NEWS

KUD 2020-20
26.11.2020

Citymaster 1650: Coolant level in expansion tank

Affected vehicles: All CM 1650 (1491.15)

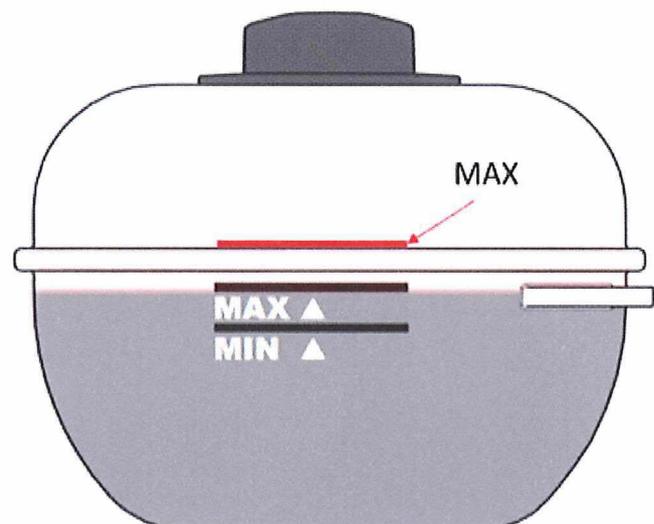
In the past few months, we received many reports on the coolant levels of Citymasters 1650 which often are displayed as being too low. Therefore, we adapted the optimal coolant level in the expansion tanks.

When the engine is cool, the coolant level should be about one centimetre **higher than the MAX mark** allows (see figure on the right). There is no need to replace the expansion tank because of this so that warranty claims can no longer be accepted for this purpose.
